## SWEC FEBRUARY SEMIMONTHLY REPORT

Subject: DCNPP-1 Independent Design Verification Program, TES February  
Second Friday Semimonthly Report

DIABLO CANYON NUCLEAR POWER PLANT  
INDEPENDENT DESIGN VERIFICATION PROGRAM  
SEMIMONTHLY REPORT  
TES - SM - JANUARY  
FEBRUARY 11, 1983

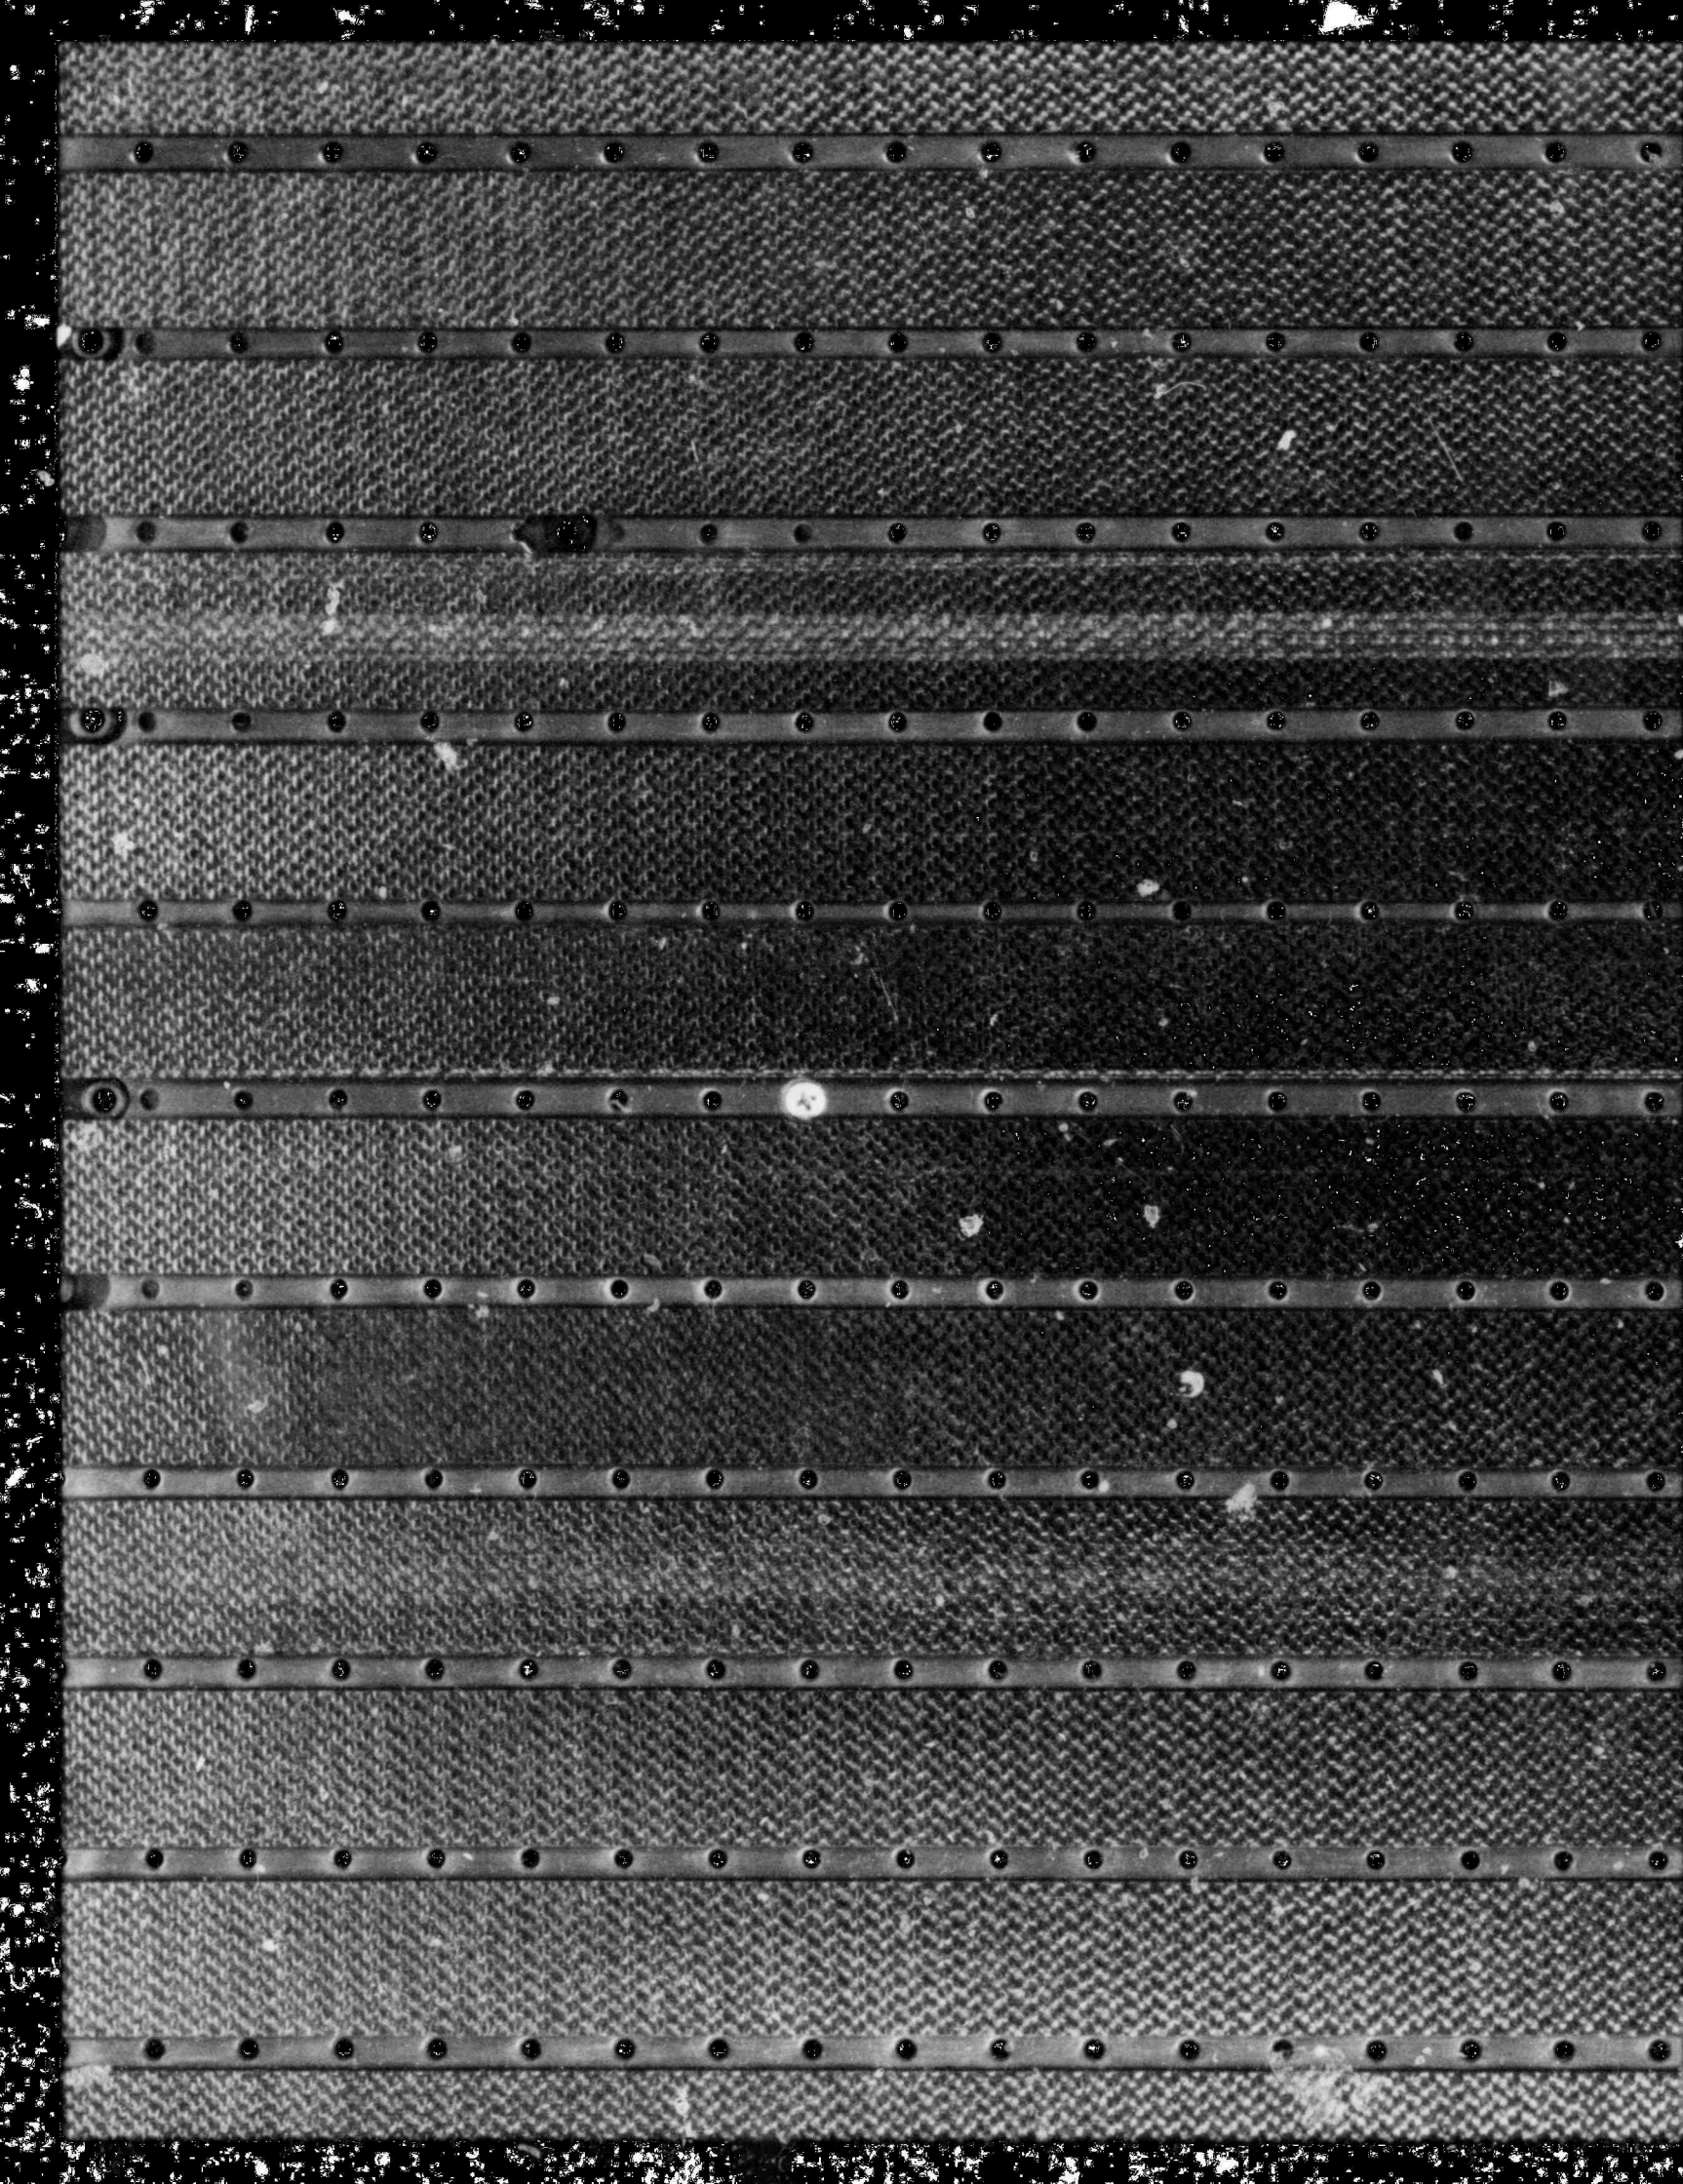
Apparent violation of separation criteria.

Possible loss of redundant circuits due to a single failure.

SWEC to review PGandE response (Ref. PGandE Completion Sheet, IDVP File No. 8043, Revision 4, signed 830124) and provide recommendation for future disposition.
